TOWN OF DAMARISCOTTA

PLANNING BOARD MEETING AGENDA

When: Monday, December 6, 2021 - 6:00 PM

Re: 35 Water Street – Expansion of Structures in the Shoreland Zone

SIE PLAN

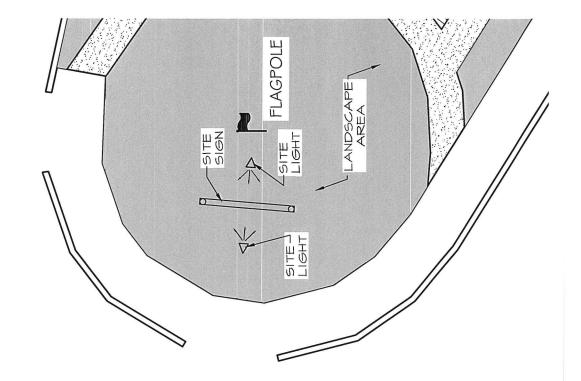
The project will involve restoring the existing information center building and constructing an addition. The existing parking area with in- and out access from Main Street would be replaced by a larger parking lot and access drive with one way in from Main Street and one way out onto Vine Street. Due to the very small size of the lot most of the trees will be removed.

The applicants were informed that the site plan will need to include information on proposed water, sewer and stormwater services. If a direct connection can be made to the municipal stormwater system, on-site detention will likely not be required.

The access drive will be immediately adjacent to the abutting property and the preferred parking arrangement will be closer than the minimum 15' setback from Vine Street. Contrary to information provided earlier to the applicant, there is no minimum required setback between the access drive and a property line and the PB can reduce the Vine Street setback rather than requiring BOA approval.

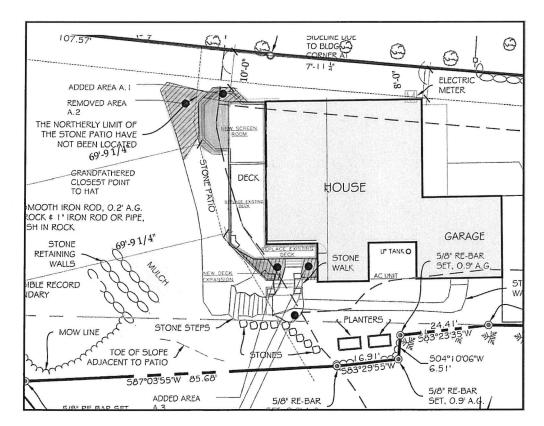
In order to better understand the proposed project, I have prepared the following sketch plan that highlights the improvements and changes proposed by the applicant.

- The existing deck is highlighted in blue
- The dashed red line is the 75' SZ setback
- The line represents the closest the existing deck is to the shore (69'- 9 1/4")
- The purple areas represent expansions (deck extension and screen room) into the 75' setback but in no instance are they any closer to the shore than the existing deck
- The green areas represent deck and screen room expansions outside of the 75' setback
- The orange area is that portion of the existing stone patio that will be removed and revegetated

Base on the lot coverage calculations supplied by the applicant, the additional impervious area within the 75' setback will be fully offset by removal and revegetation of a portion of the stone patio.

The property is in the Residential District, which requires a 15' side setback. The existing building is slightly more than 7' from the sideline, which makes it legally non-conforming. The applicant is requesting permission to extend the northerly side of the screen house to within 10' of the side lot line.

Staff recommends that the PB schedule the project for a site visit. I have asked the applicant to stake out the locations of the proposed improvements, setback lines and the portion of the patio to be removed.
